Access Compliance Report

Public Rights-of-Way

Intersection ID: 9129	Main Street: N_GRAHAM_ST	Cross Street: NORRIS_AV	Location:	S
ADA ID: A90440D971D7	Ramp Type: Combination1	Initial Pass/Fail: Fail	Overall Compliance: No	Severity Score: 8.75
Codes/Mitigation Info/Possible Solution		Field Measurements/Component Compliance

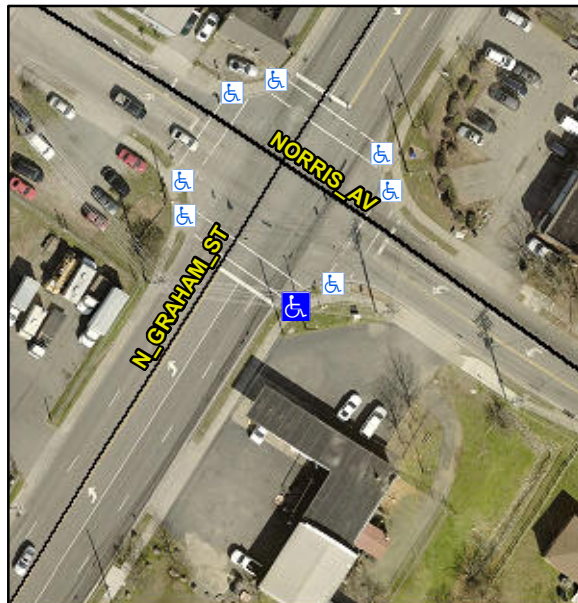
LT RP < 5%

Not Found, R304.5.1

Remove & Replace Entire Ramp.
